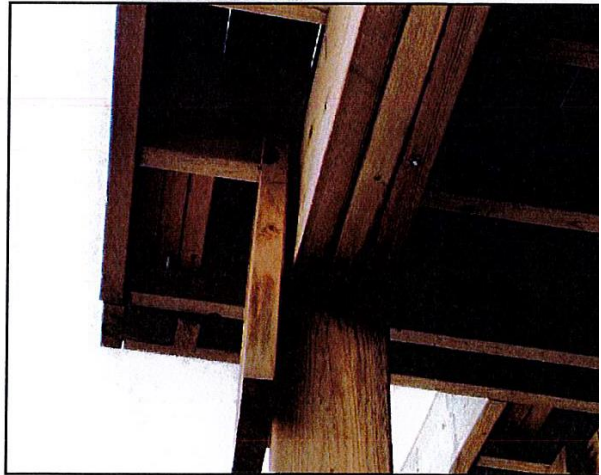
**Condition:** • The ledgerboard for the deck is bolted through the brick veneer. Brick veneer should not support floor load. If the brick veneer were removed, the deck would clearly move, even if lag-screwed to wood four inches away from the ledger. Lag bolts cannot cantilever to support the load of the deck. [OBC 9.23.2.1]

**Location:** Rear Deck
